**SUBJECT: Trimming chassis mounted Battery Cage Brackets**  
**MODEL YEARS: 2024 & Beyond**  
**AFFECTED MODELS: UU Model THREE**  
**INITIATION DATE: 08/29/2023**  
**REVISION: 10/05/2023**

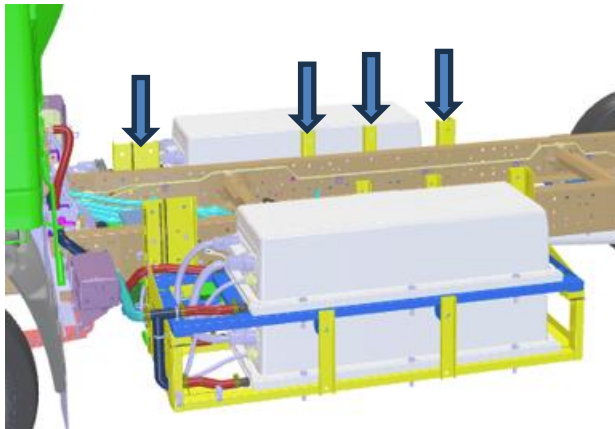
**Description of Concern:** Some chassis mounted Battery Cage Brackets that run vertically attached to the outside frame rail may be intrusive to upfit body mounting. These brackets can be trimmed down based on instruction below. If bracket height is not a concern, they can be left as is.

Vehicle ignition should be off, chassis should be non-operational. Follow Mullen UI Best Practices Chassis Section Safety Protocol for chassis modifications.

- Trim vertical brackets down with a compatible reciprocating saw, flush to top of frame. Gaseous Torch cutting is not recommended.

- Remove any burrs and sharp edges off shortened brackets. Seal any bare metal areas with chassis paint.
- Once completed restore any disabled chassis systems. Follow Mullen UI Best Practices Safety Protocol.
